SERVICE BULLETIN

M-1253

2008-2010 FXDF/FXDFSE AND 2010 FXDWG CRITICAL FASTENER LIST UPDATE

Figure 1. Dyna Exhaust Bracket

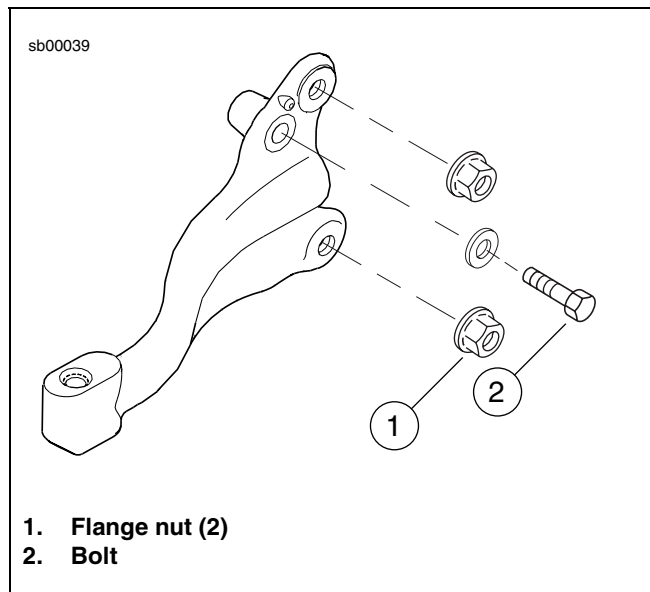
The purpose of this bulletin is to inform technicians to check exhaust bracket torque at every service interval. The powder-coated surface yields in the joint clampload over time. Performing this torque procedure at every service interval will prevent loosened or broken fasteners.

See Figure 1. Tighten exhaust bracket mounting bolt (2) and flange nuts (1) at transmission to 15-19 ft-lbs (20.3-25.8 Nm) at every service interval in addition to other fasteners on the critical fastener list.
